HARRISVILLE STATE PARK
BITUMINOUS SURFACING OF TRAIL
DNR PROJECT No. 24-3226
ADDENDUM No. 1

SUBJECT: This Addendum No. 1 is issued to revise the Contract Documents for the above referenced project.

Harrisville State Park - Day Use to Town Trail Connection - Engineering

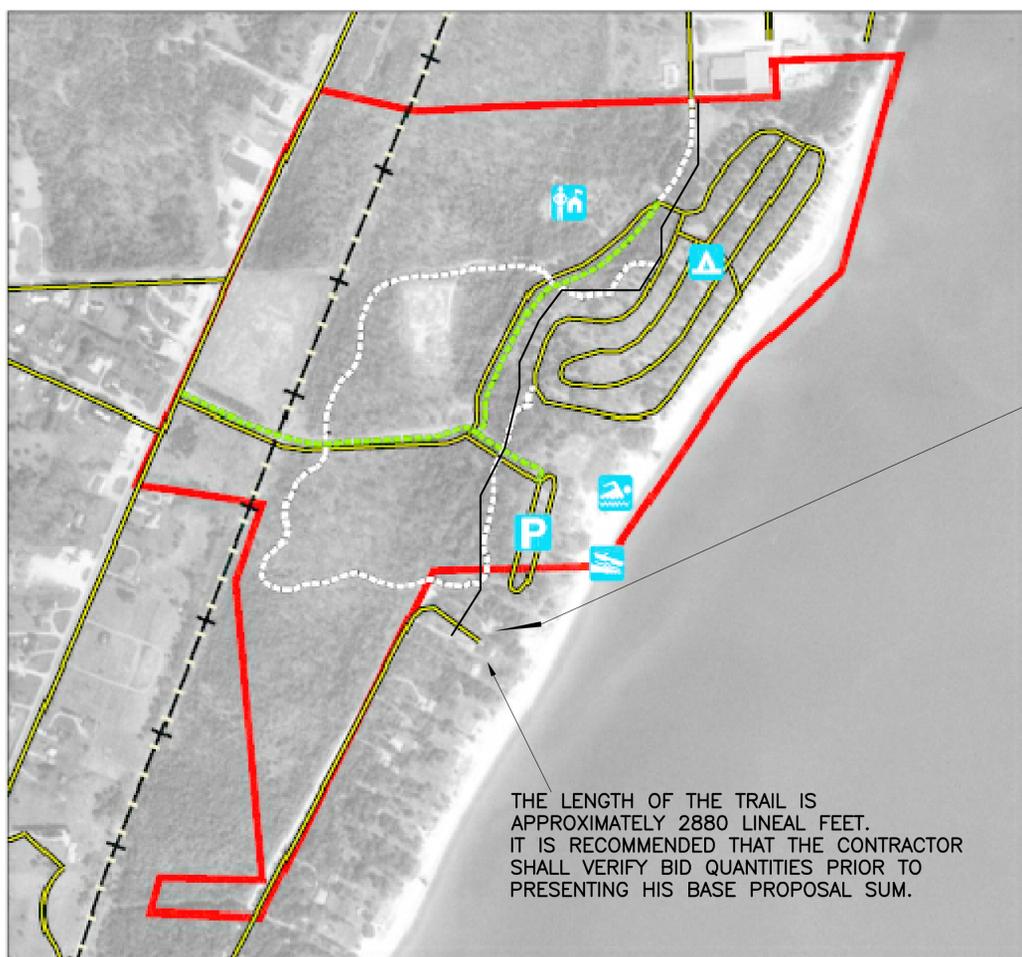
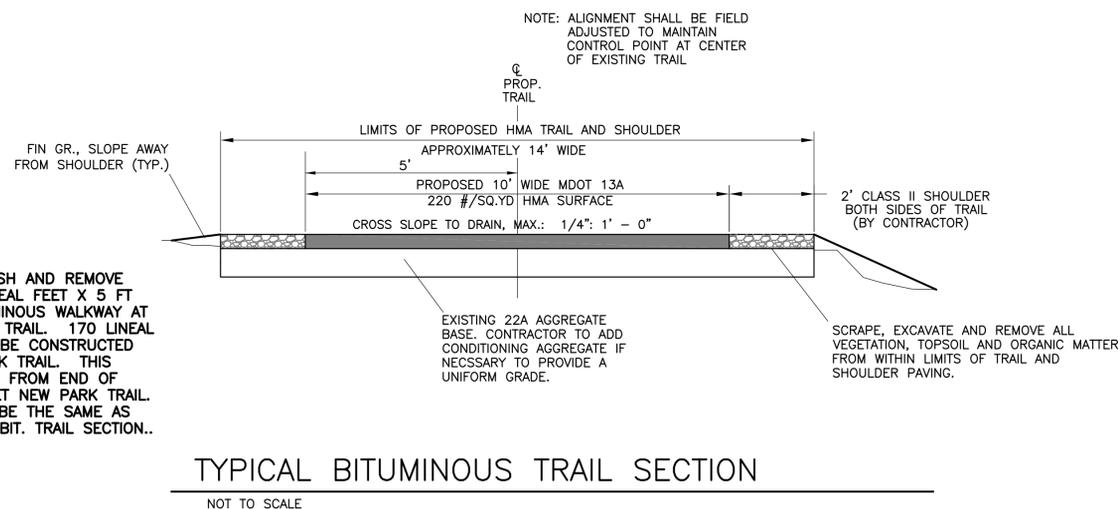
CONTRACTOR TO DEMOLISH AND REMOVE APPROXIMATELY 360 LINEAL FEET X 5 FT WIDE OF EXISTING BITUMINOUS WALKWAY AT END OF SOUTH END OF TRAIL. 170 LINEAL FEET OF NEW TRAIL TO BE CONSTRUCTED AS SPUR FOR NEW PARK TRAIL. THIS SHALL BE CONSTRUCTED FROM END OF PARK PROPERTY TO MEET NEW PARK TRAIL WIDTH AND GRADES TO BE THE SAME AS SPECIFIED FOR TYPICAL BIT. TRAIL SECTION..
